**49 CFR Parts 571 and 585
Federal Motor Vehicle Safety Standards;
Head Restraints; Final Rule**

Federal Motor Vehicle Safety Standards; Head Restraints**AGENCY:** National Highway Traffic Safety Administration (NHTSA), DOT.**ACTION:** Final rule; response to petitions for reconsideration.

SUMMARY: This document completes the agency's response to petitions for reconsideration of the December 2004 final rule upgrading our head restraints standard. We are partially granting and partially denying the petitions.

Figure 1. Risk of Whiplash Injury versus Head to Torso Rotation on the Hybrid III 50th percentile male dummy

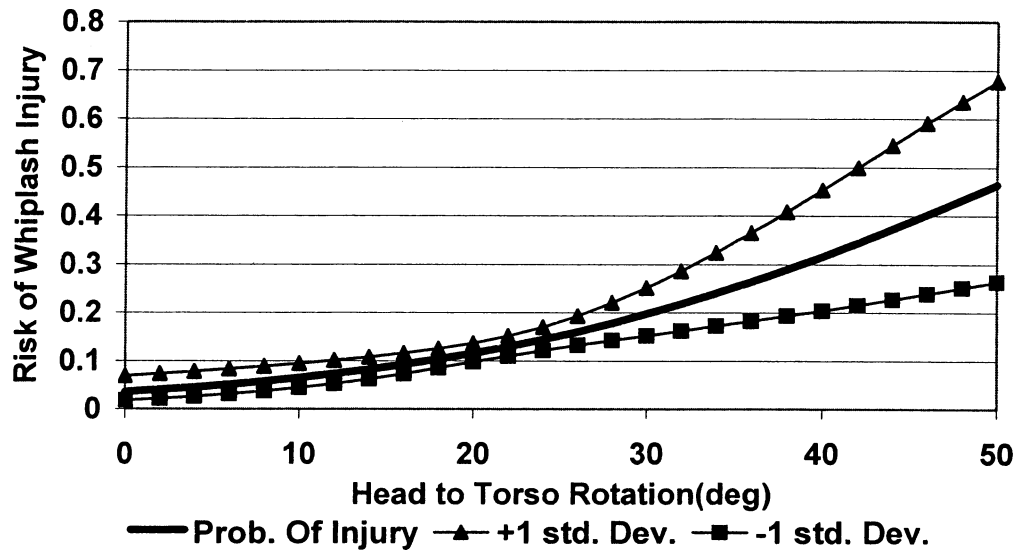
Unfortunately, the agency incorrectly presented in the final rule preamble a graph of head displacement rather than

head rotation (69 FR at 74874). The graph should have been the following:

This correct graph addresses some of the questions raised by the petitioners.

Figure 4 of §571.202a – Portion of gap above 540 mm height.

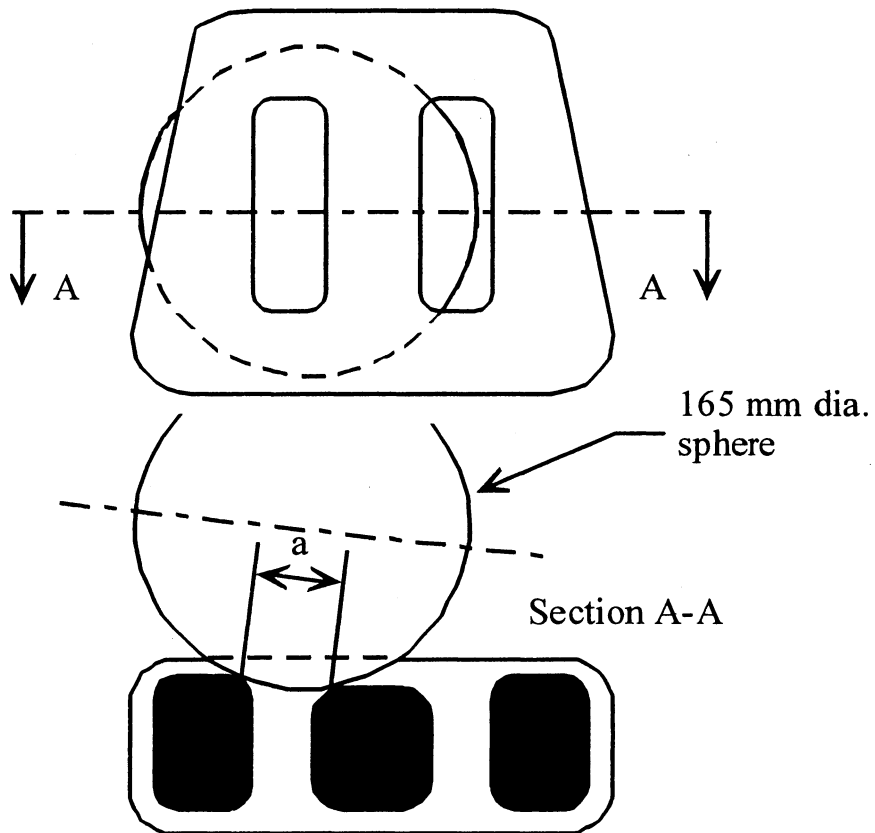
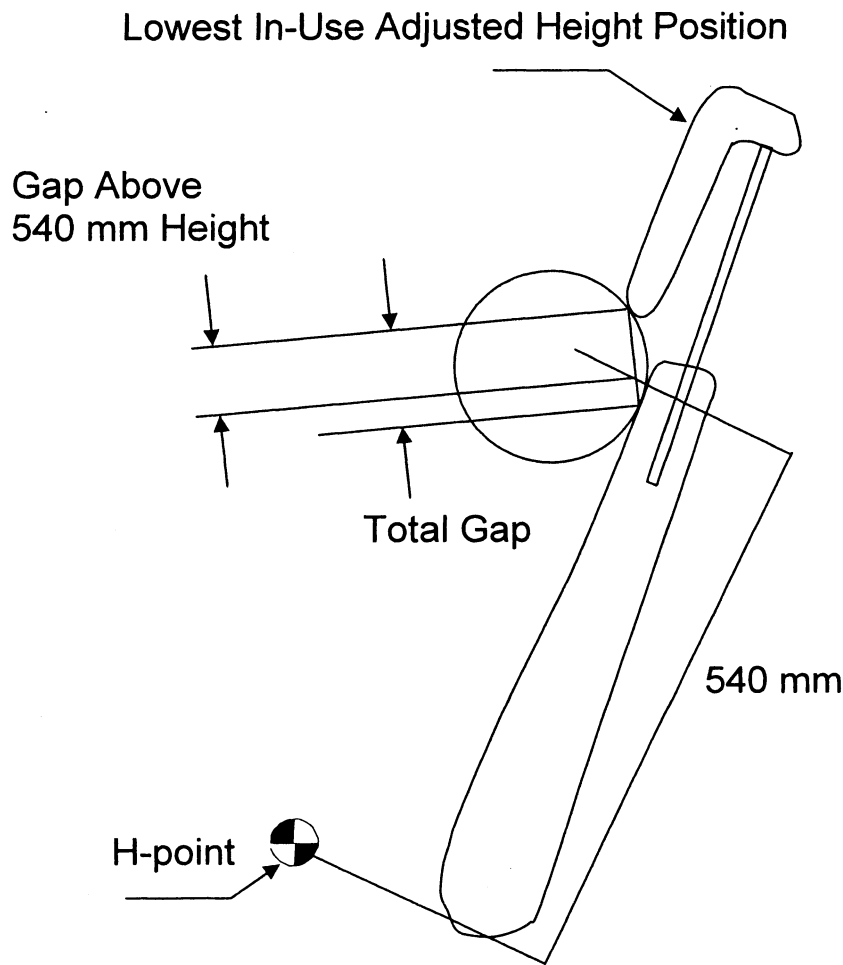
Also, we are adding a new Figure 4 that we believe will help clarify the requirement when using the sphere.
